UNITED STATES PATENT AND TRADEMARK OFFICE

APPLICATION NO.	FILING DATE	FIRST NAMED INVENTOR	ATTORNEY DOCKET NO.	CONFIRMATION NO.
10/673,276	09/30/2003	Masahiro Nozaki	26E-003	1581

Office Action Summary	Application No. 10/673,276	Applicant(s) NOZAKI, MASAHIRO	
	Examiner Gregory J. Strimbu	Art Unit 3634

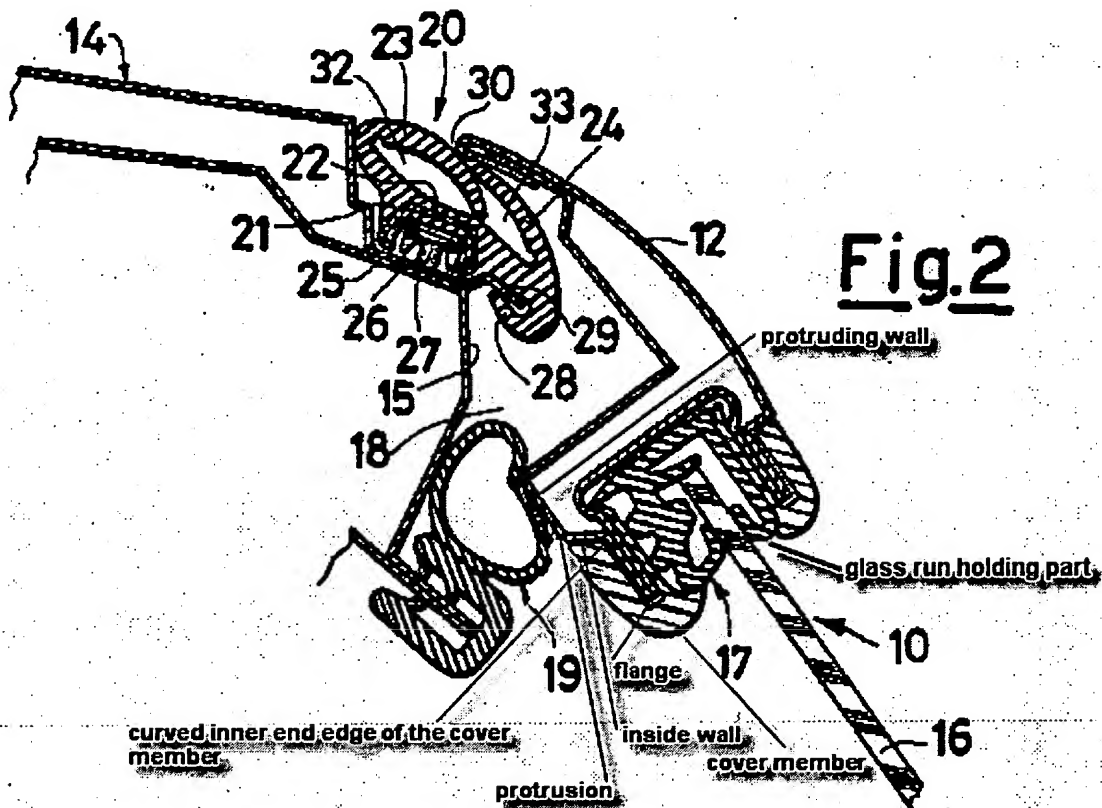
Claims 1, 8, 9 and 18 are rejected under 35 U.S.C. 102(b) as being anticipated by Villa et al. Villa et al. discloses a door seal structure in combination with a door frame 12 of a vehicle door 10 for sealing between a door opening portion (not numbered, but shown in figure 2) of a vehicle body (not numbered, but shown in figure 1) and the door frame, comprising an opening weather strip 19 adapted to be attached to the door opening portion, said opening weather strip including a tubular seal portion (not numbered, but shown in figure 2) which projects outwardly of the door opening portion, a glass run 17 for guiding a door glass 16 that is raised and lowered, said glass

run being held in a glass run holding part (not numbered, but shown in figure 2) provided along an inner peripheral portion of the door frame, a protrusion (not numbered, but shown in figure 2 comprising the portion of the door frame extending generally downwardly and to the left lower corner as shown in figure 2) in the door frame, wherein the protrusion protrudes inwardly of said glass run holding part since it extends inwardly of the glass run holding part, an inner peripheral end of said protrusion being joined to an inner side wall of said glass run holding part to define a flange (not numbered, but shown in figure 2), said protrusion including a protruding wall (not numbered, but comprising the part of the protrusion engaging the weather strip 19 as shown in figure 2) and an inside wall (not numbered, but shown in figure 2 spanning the distance between the protruding wall and the flange), said protruding wall being adapted to contact and press said tubular seal portion of said opening weather strip and said inside wall being located to face a vehicle compartment when the vehicle door is closed, said inside wall of said protrusion having a depression (not numbered, but shown in figure 2 where the inside wall transitions to meet the flange) that is formed immediately adjacent to said protruding wall so as to extend in a longitudinal direction of said protrusion, and a cover member (not numbered, but shown in figure 2 extending over the flange and extending into the depression) that extends to cover said inside wall of said protrusion of the door frame, an outer end edge of said cover member covering said flange and being connected to said glass run and an inner end edge of said cover member (not numbered, but comprising the portion of the cover member extending into the depression) being curved at an angle to an extending direction of said cover

member and being seated in said depression, wherein when the vehicle door is closed, said inside wall of said protrusion is substantially covered with said cover member such that said inner end edge of said cover member does not contact said tubular seal portion of said opening weatherstrip.

The applicant's comments concerning the inner end edge of the cover member not contacting the tubular seal portion are not persuasive because they are no more than mere supposition. Figure 2 of Villa et al. clearly discloses the inner end edge of

the cover member not contacting the tubular seal portion and accordingly anticipates the applicant's claimed invention.
